T10/07-361r5

<b>To</b>	<b>From</b>	<b>Subject</b>	<b>Date</b>
INCITS T10 Committee	Curtis Ballard, HP Michael Banther, HP	SSC-3 Out of Band Encryption Key Management	<u>13</u> November, 2007

Figure 8 — UML example of SCSI target device and physical device

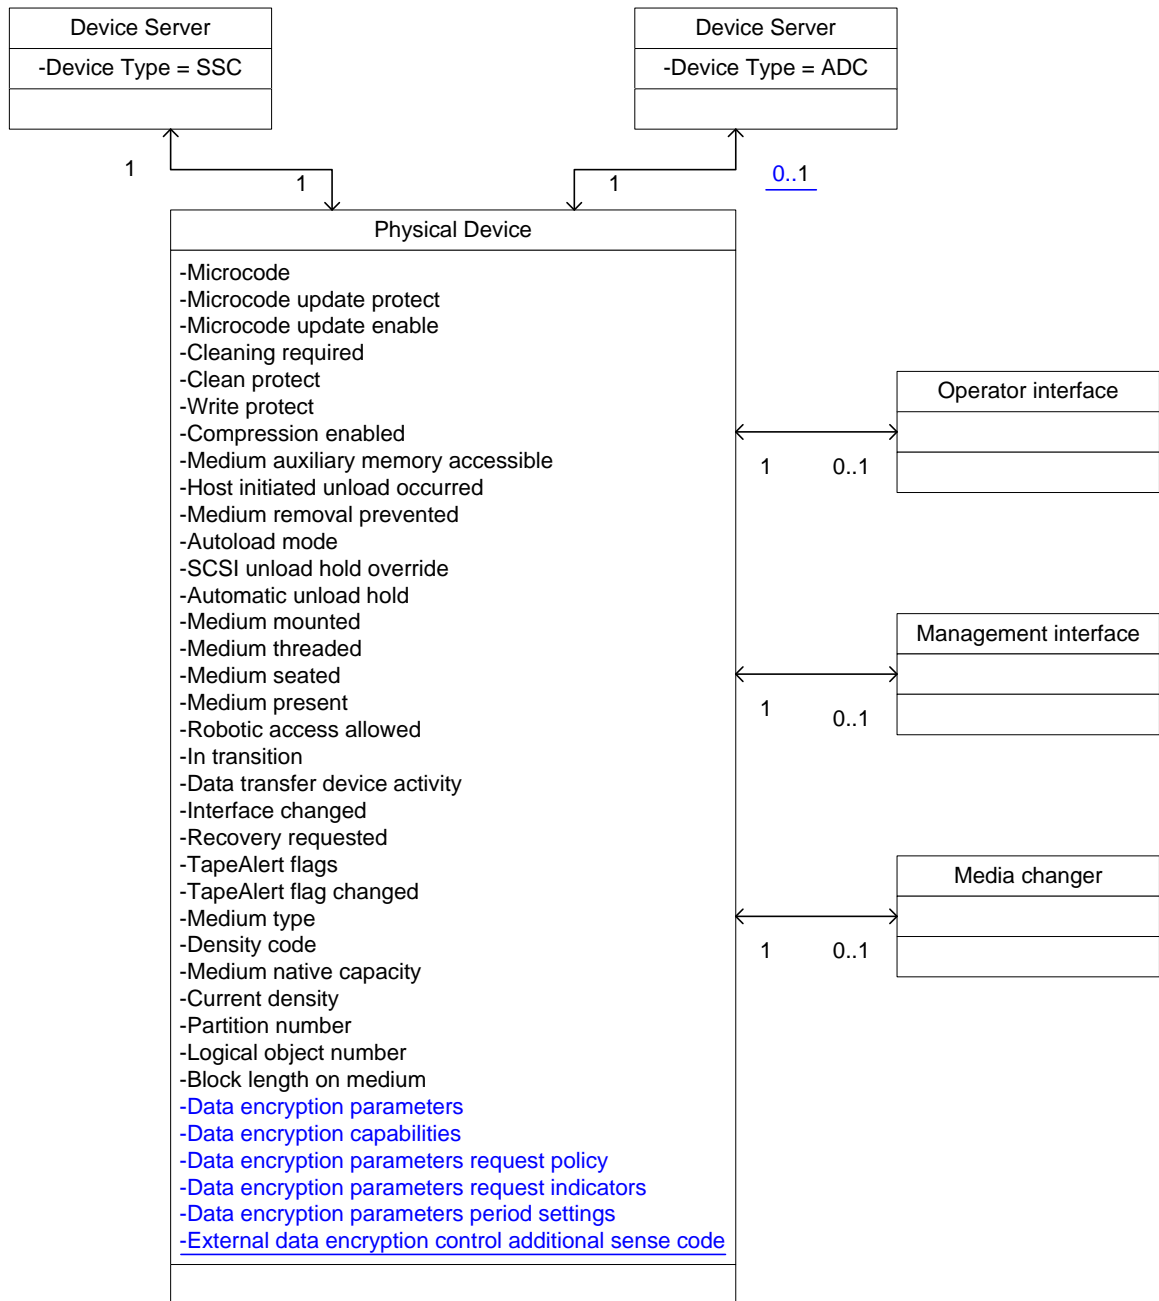
Add data encryption parameters, capabilities, request policy, request indicators, period settings, and ASC to figure 8.
